Bulletin No: TSB-1200

Models: A0014967PGH

Subject: Terminal ID from A0014967PGH to BLP4009

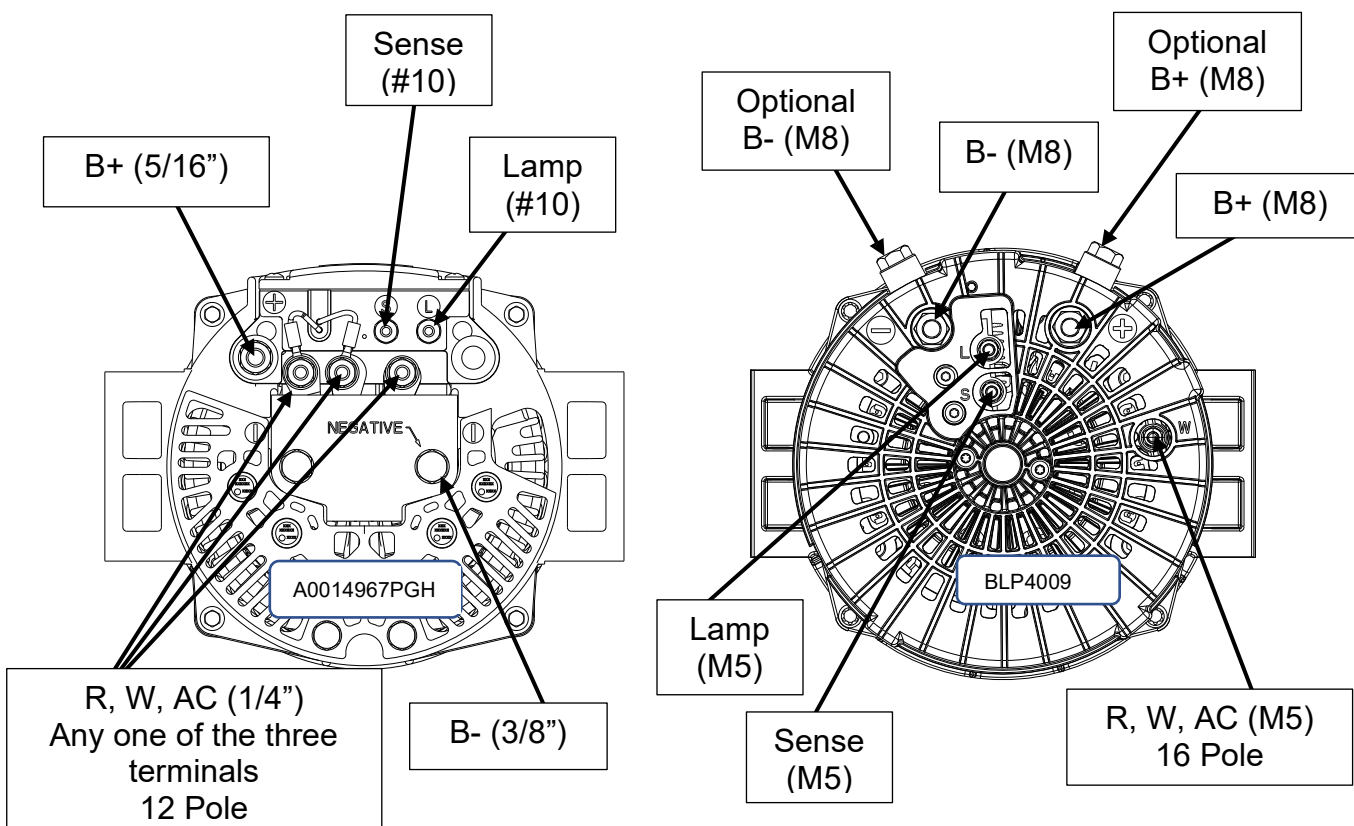
Brush alternator A0014967PGH can be replaced by brushless alternator BLP4009.

This document will help identify terminal location variances.

Note: Wire termination and routing will require changes.

A0014967PGH is grounded earth return where the BLP4009 replacement alternator is insulated return. Depending on the vehicle wiring a ground strap may be required.

BLP4000 series alternators has a pad mount bracket that uses a short span (108mm) where the 4900 series uses a span of (126mm). Most engine brackets have the ability to accommodate both spans. Please verify your engine bracket and refer to TSB-1049 for more information.
